Groundwater & Wastewater Services
Septic Project File & Data Review Worksheet

GWS Septic System Design Review

RE: Request for an Improvement Permit for Lot 1 off of Sample Road.
MCHD File #6739B

SEPTIC SYSTEM DESIGN REVIEW WORKSHEET

Scale: 1 inch equals 50 feet	S&ME	Faison-Sample Road, LLC	FIGURE
Drawn by: JBP		Lot 1	1
Reviewed by: Jeremy P. Michelone, RS		Mecklenburg County, NC	
Date: February, 2007	ENVIRONMENTAL SERVICES · ENGINEERING · TESTING	S&ME Project #1588-05-091

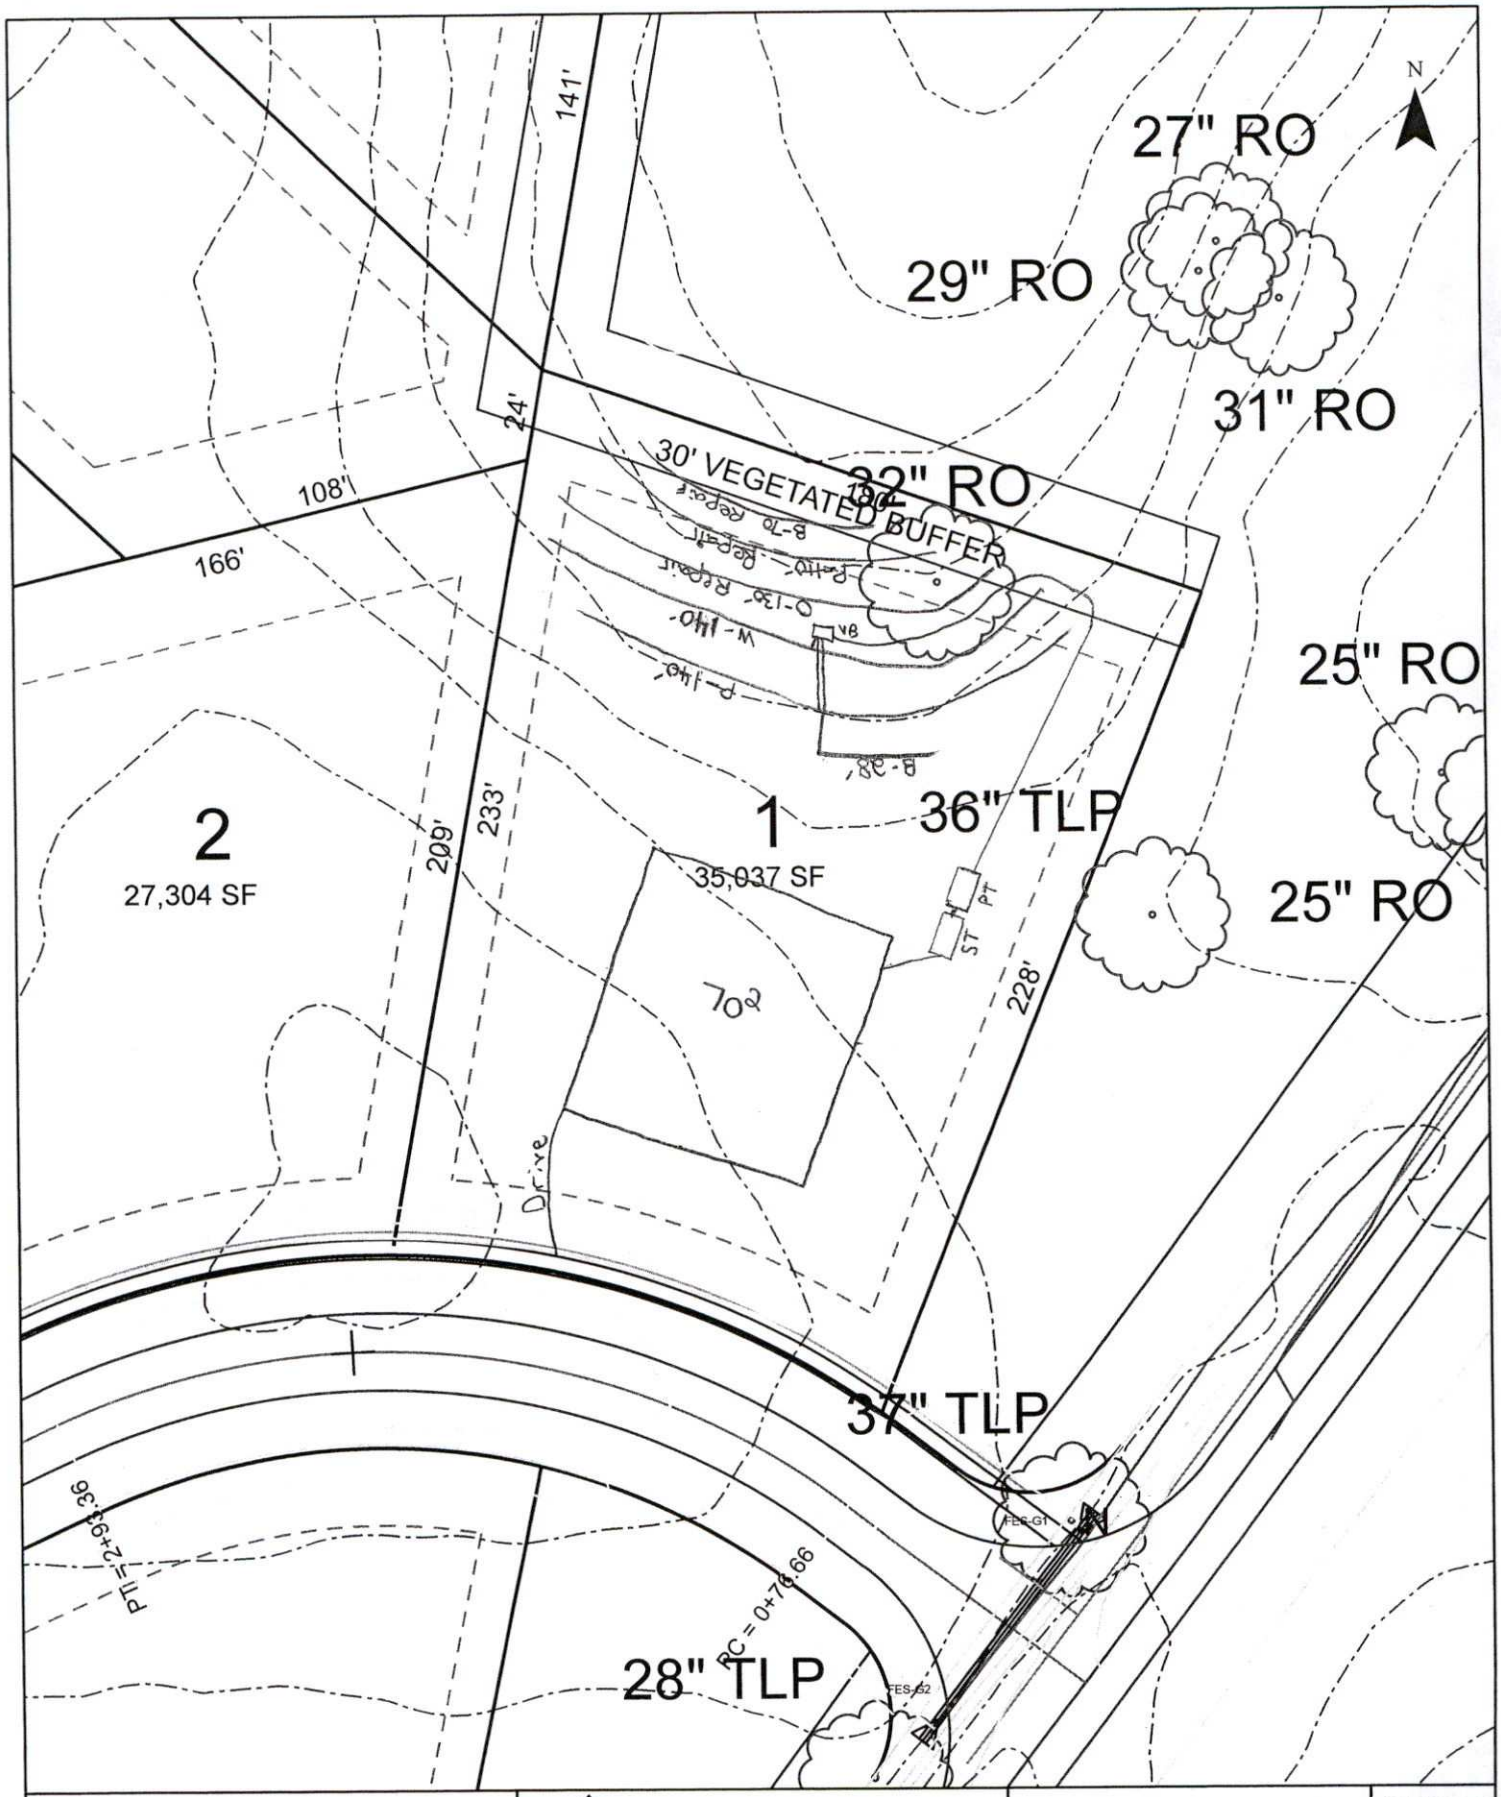
1. No Modified Plot Plan application on file for project. Need application & fees. Must enter into WASPS for permitting.
2. Hole #4 from soil report shows soil depth of 37". Need clarification from Bill Marlin to determine if soil depth is adequate for PPBPS system type specified for area.
3. Soil report needs to be updated to show review for 5 bedroom house (600 GPD).
